MINUTES
**BOARD OF BUILDING STANDARDS/
ARCHITECTURAL BOARD OF REVIEW/SIGN REVIEW**
REVIEW MEETING
CITY OF LAKEWOOD
12650 DETROIT AVENUE
AUDITORIUM
OCTOBER 13, 2022
5:30 P.M.
PARTIALLY RECORDED MEETING
<https://www.lakewoodoh.gov/videos-2/>

Docket No. 08-49-22 (1491 Spring Garden)

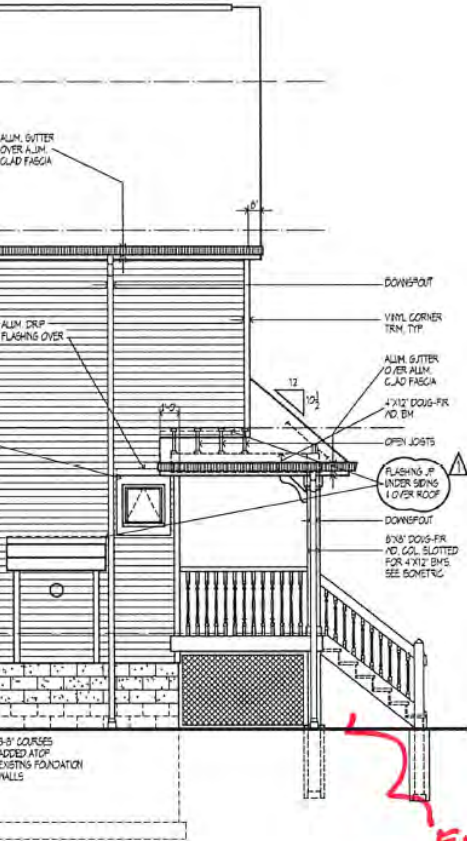
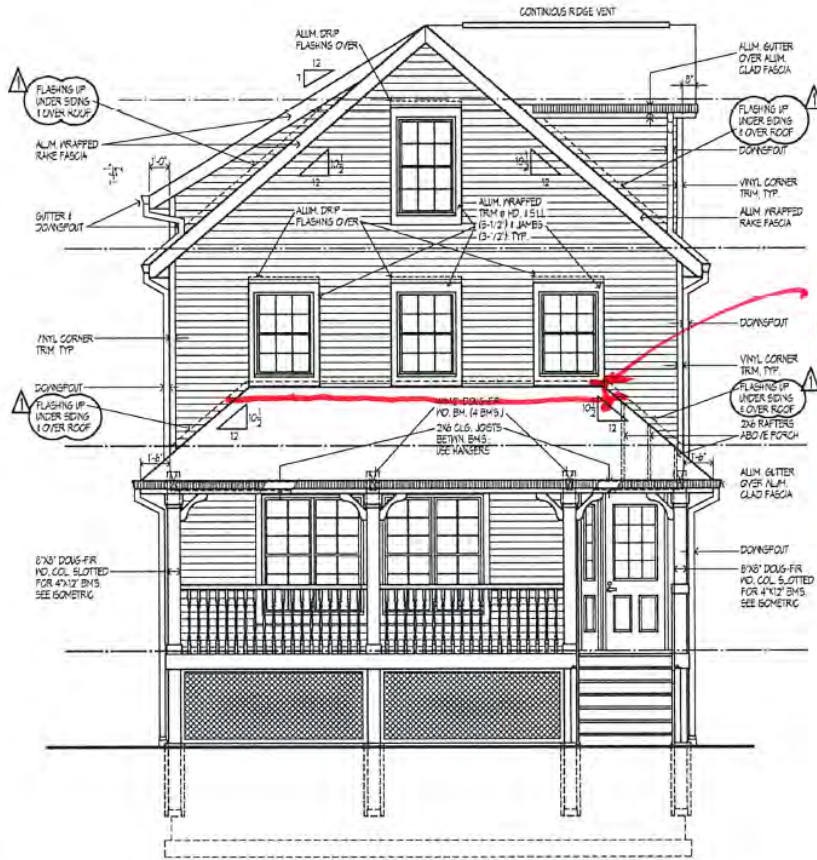
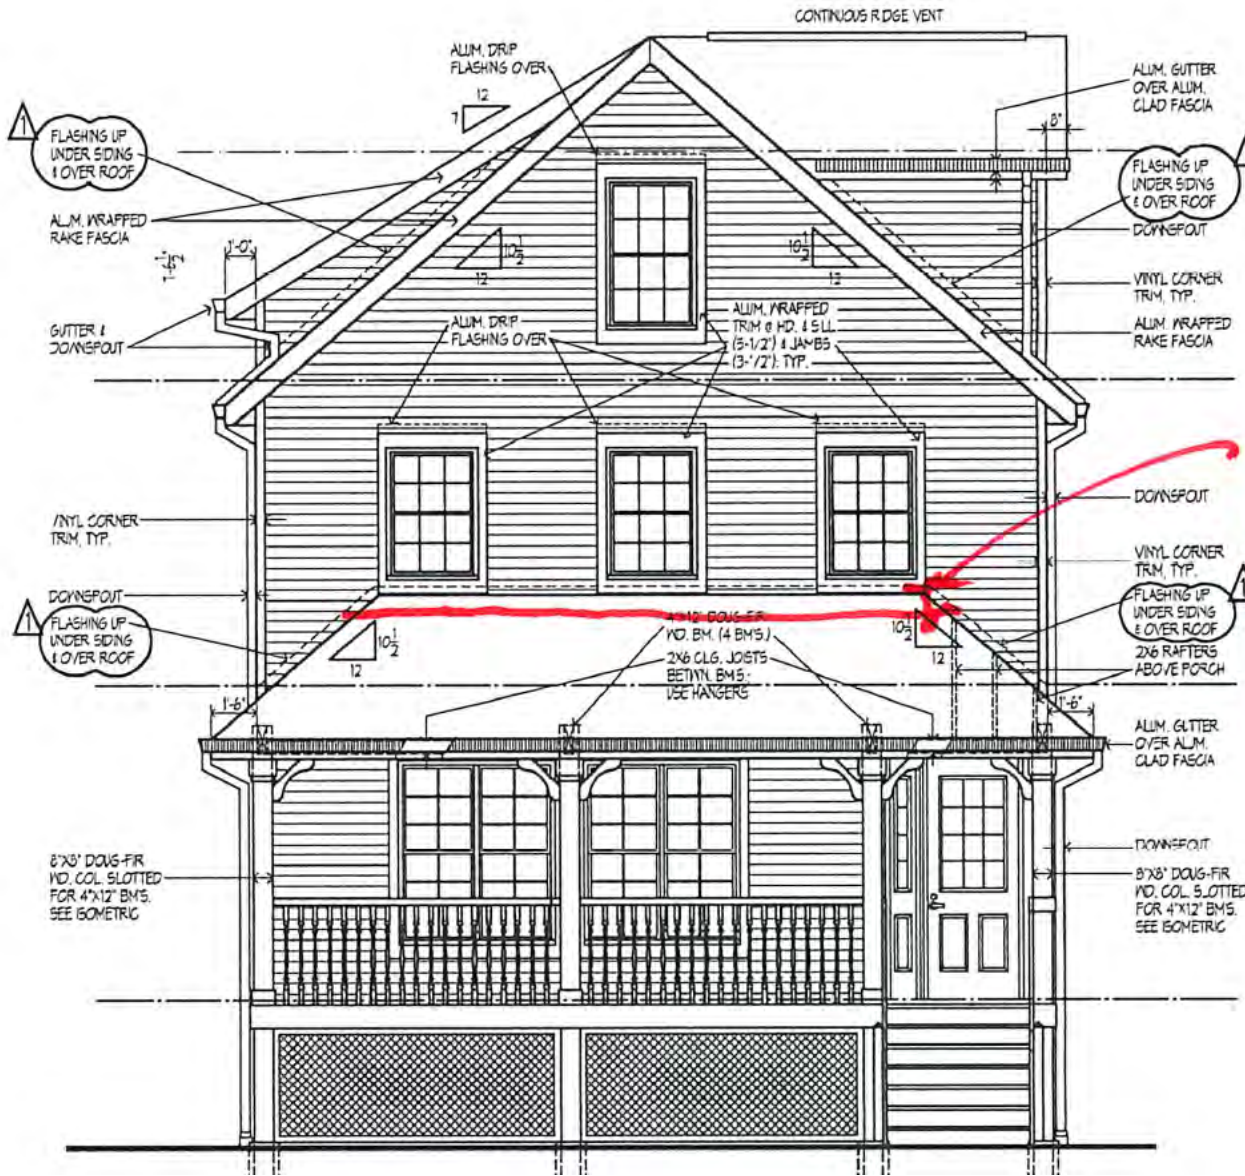
David Harala, DHA Architects Ltd., representative was present to explain the request. Discussion began about the door, window, the porch skirt, shingle trim, paint to tie everything together; a photograph taken by staff that afternoon was used as the current rendering. Staff said the conditions had been met. Public comment was closed as no one addressed the item. The members encouraged the applicant to communicate more thoroughly with the city in the future.

*ENCLOSE W/
LATTICE*

*DROP 4 1/2"
ROOF AT LEAST
8" BELOW
WINDOWS.*

- **The shingle trim will be painted to match (black).**

Docket No. 10-67-22 (13471 Lake)
 Residential – Second Floor Addition

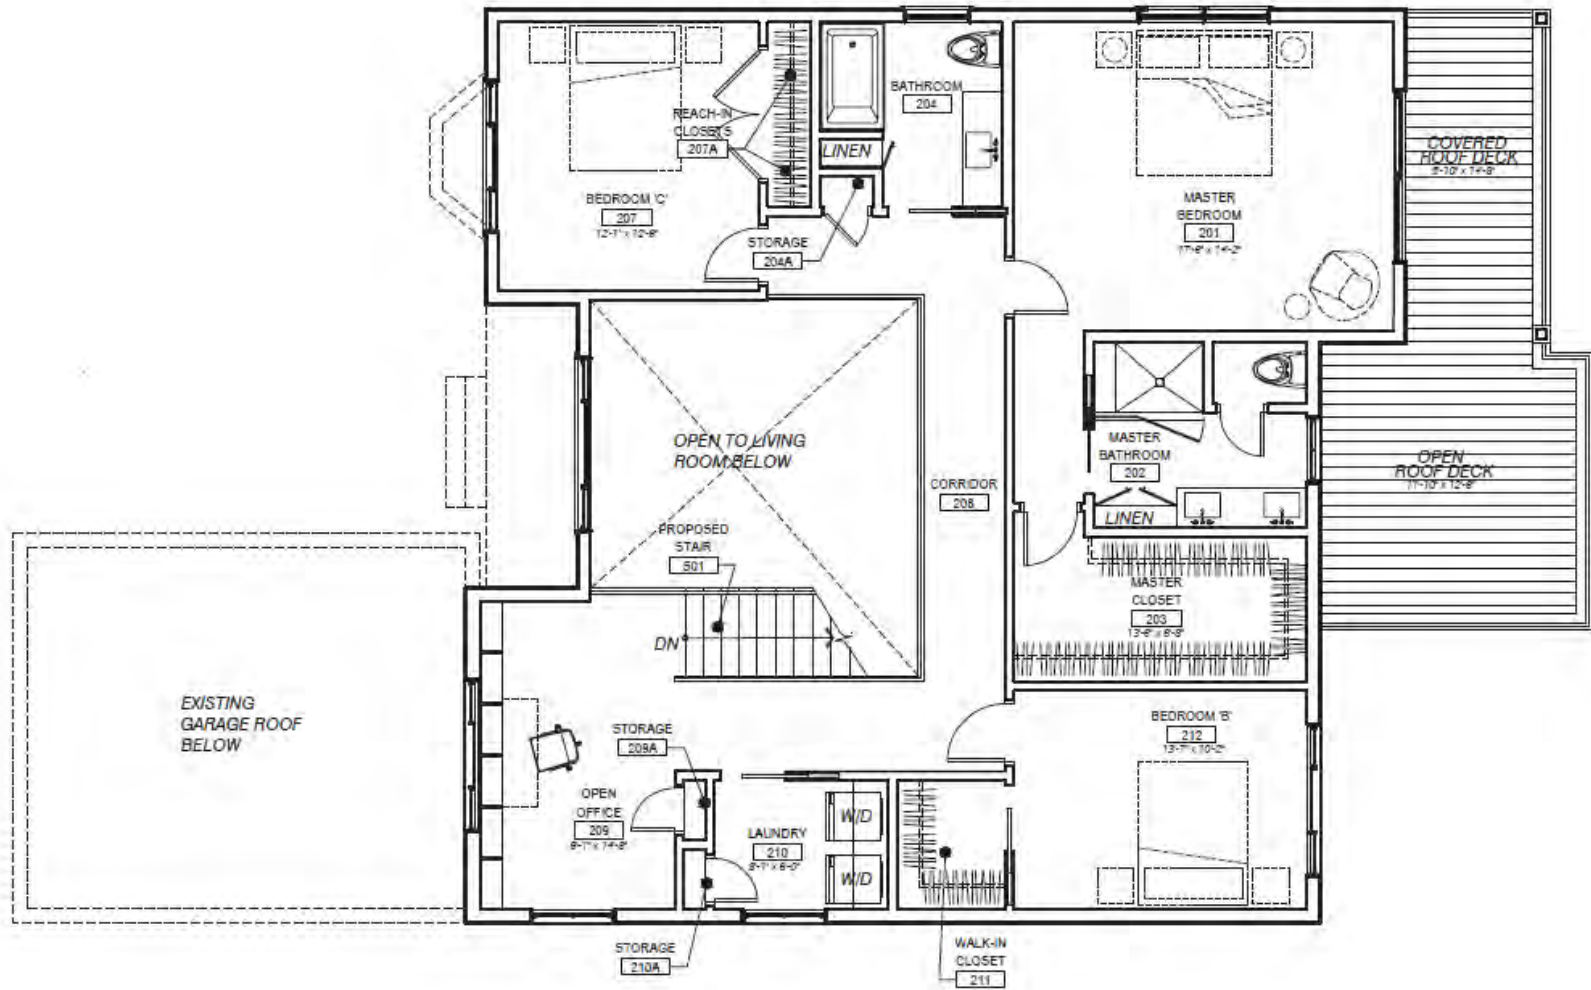
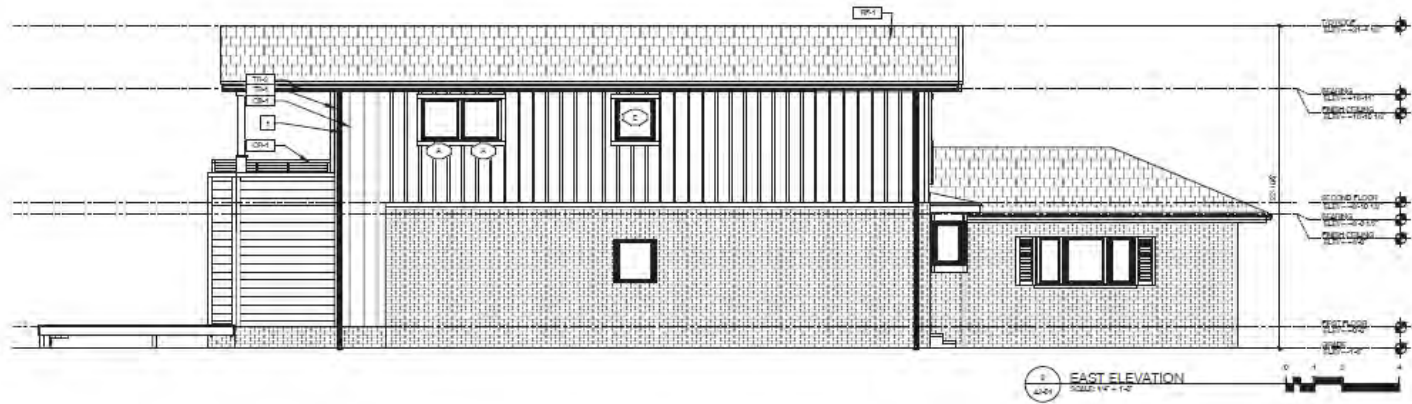
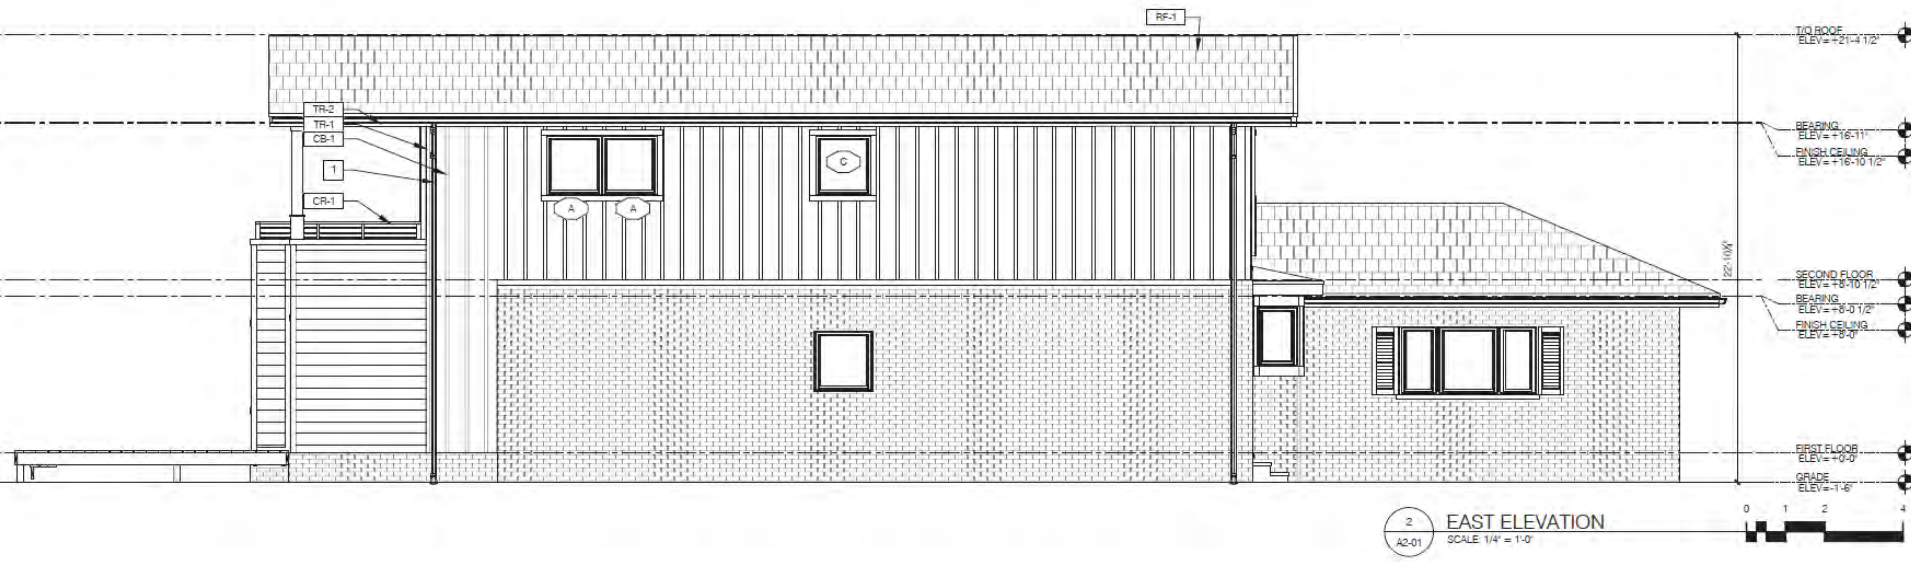
Brandon Young, Young Design Studio, applicant and Ron Kolodziej were present to explain the request. The members liked the proposal but not the shutters next to the first floor bay window. It would be before the Board of Zoning Appeals on Thursday, October 20th for approval. Public comment was closed as no one addressed the item. Staff had no comments.

- **There will be no shutters on the first level**
- **Shutters will be allowed on the second level.**

2 BRICK MASONRY TRASH ENCLOSURE DETAILS
NT8

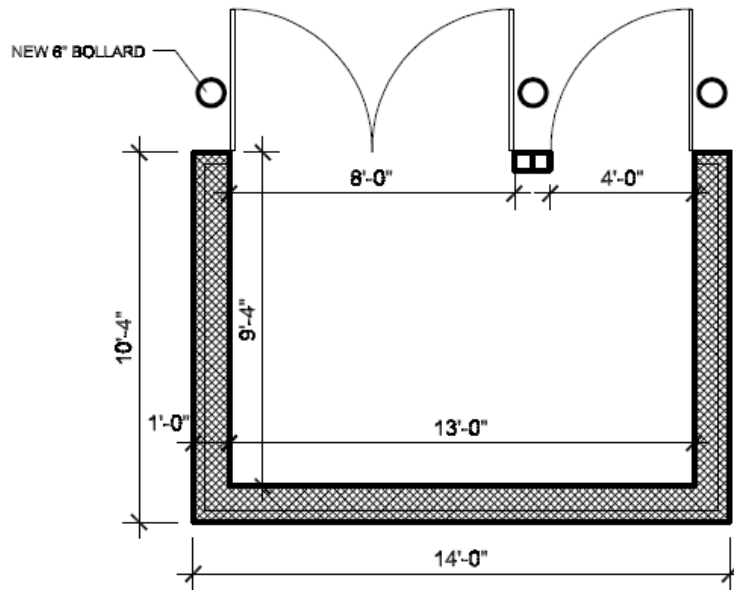
Leon Sampat, LS Architects, applicant was present to explain the request. The members liked the proposal. Discussion continued about the outdoor seating and tables, fence, colors, trash enclosure. Public comment was closed as no one addressed the item. Staff stated signage would be submitted later, and the proposal would be heard by the Planning Commission for outdoor dining and parking lot to the north of the building.

- **The brick used for the Dumpster enclosure will match the brick used on the building.**
- **The storefront framing material will be black anodized except for the central portion (within the brick) that will be a teak as on the plans.**
- **The rear fence at property line will be approved administratively as per city fence code.**

Docket No. 10-69-22 (15320 Detroit)
Sign - Tapster

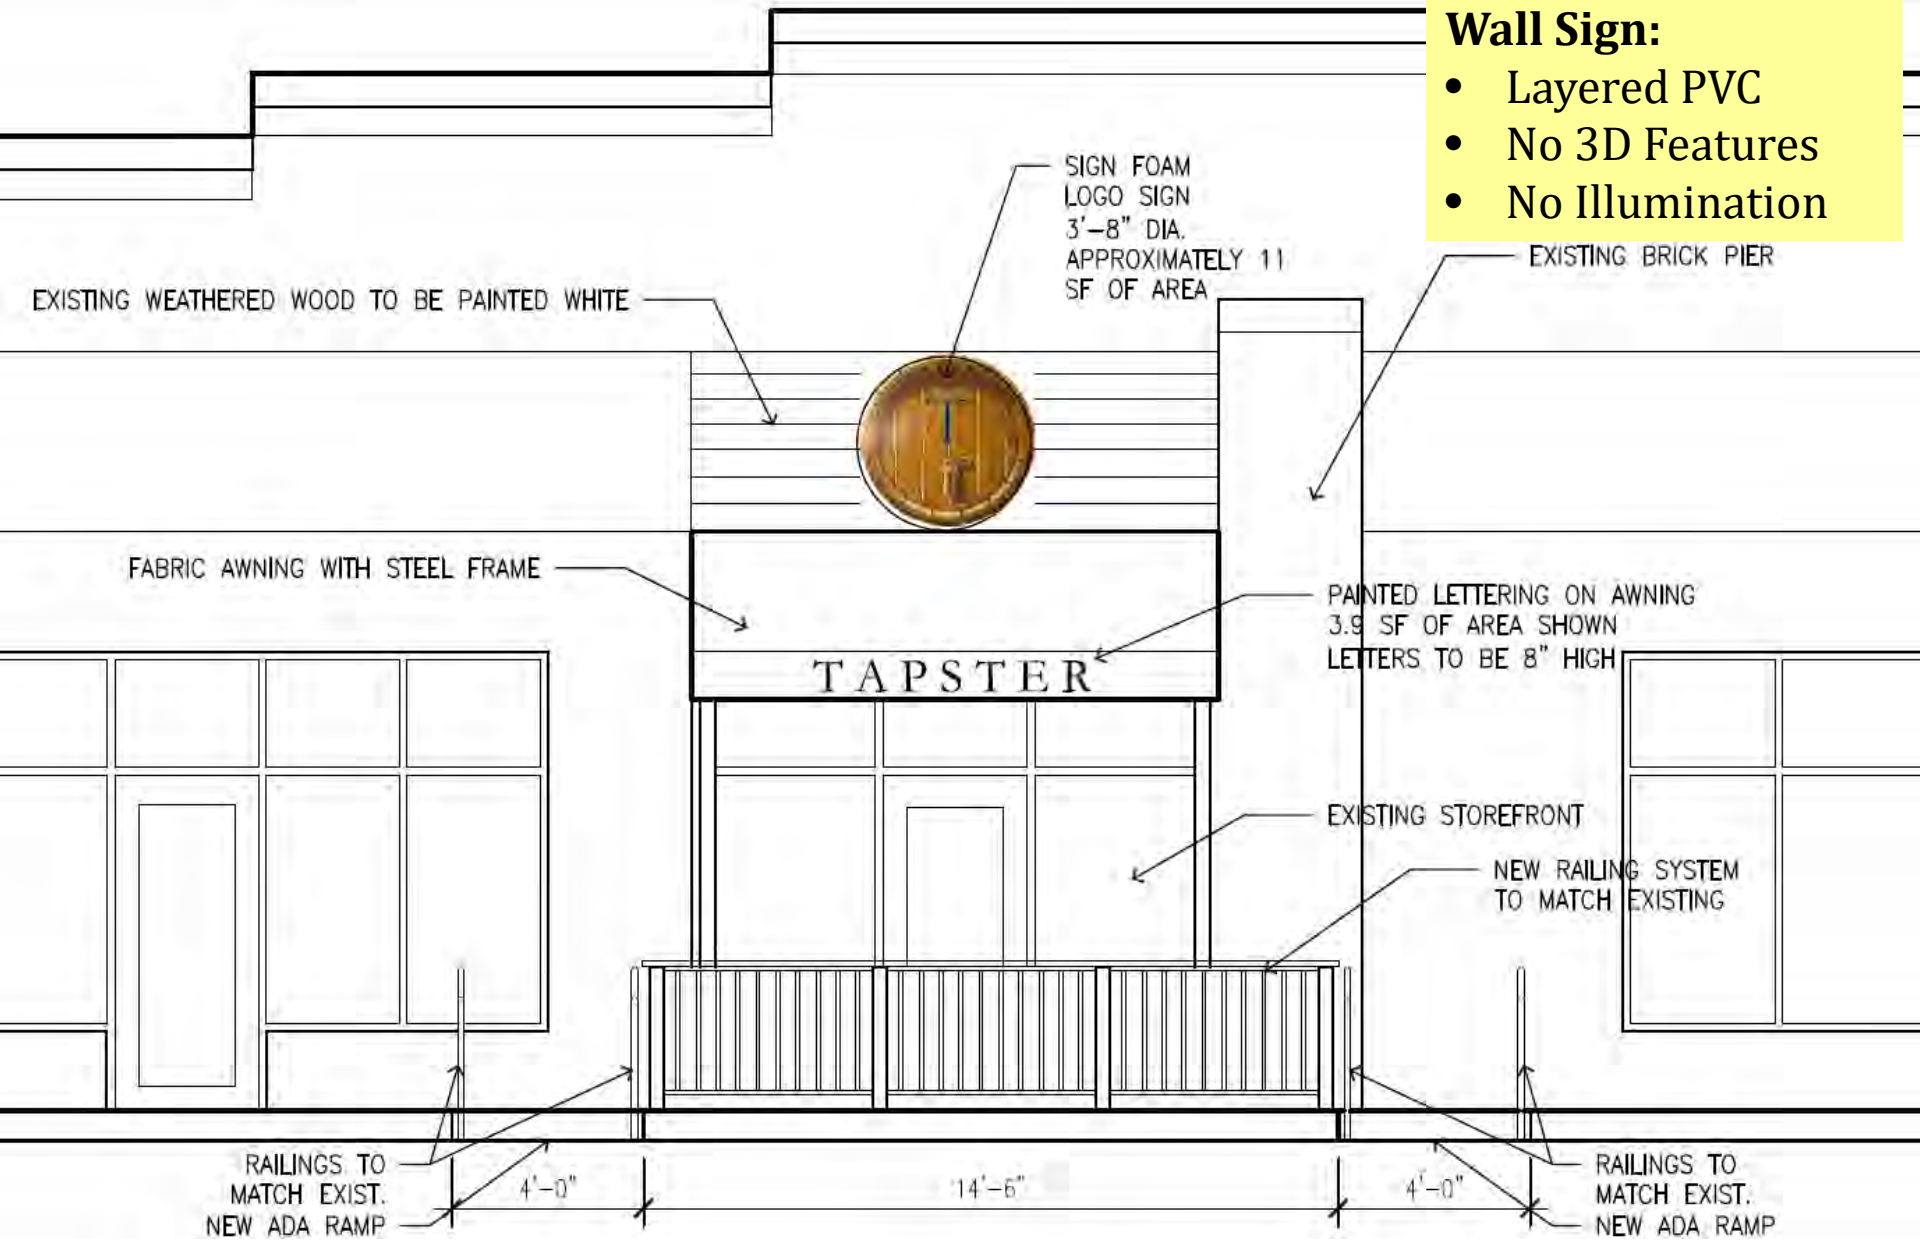
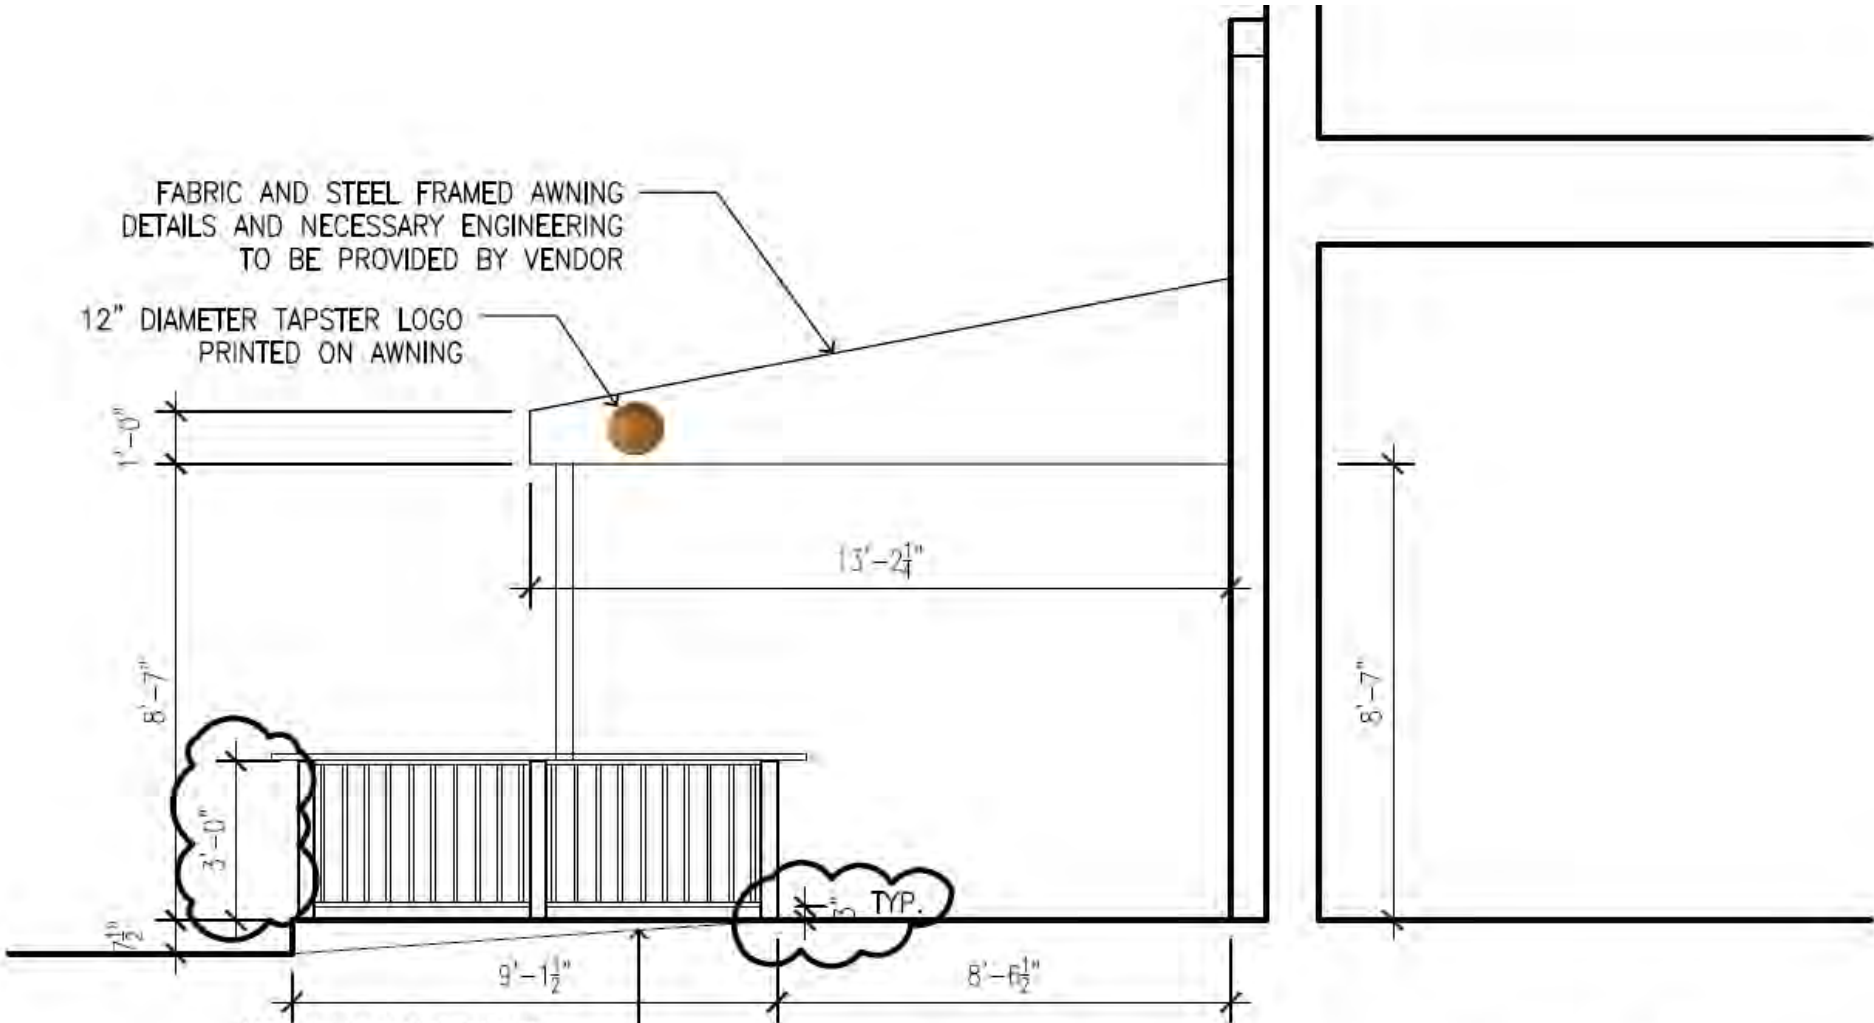
Jordan Kay, Tapster Cleveland, applicant was present to explain the request. There was discussion about the barrel logos on the side of the awnings, colors, font size. Public comment was closed as no one addressed the item.

12" DIAMETER TAPSTER LOGO
PRINTED ON AWNING

- **The primary logo will be three foot in diameter and centered within the wood sign band.**
- **The medallion logo on either side of the awning will be the same height as the font primary lettering on the front edge of the awning.**
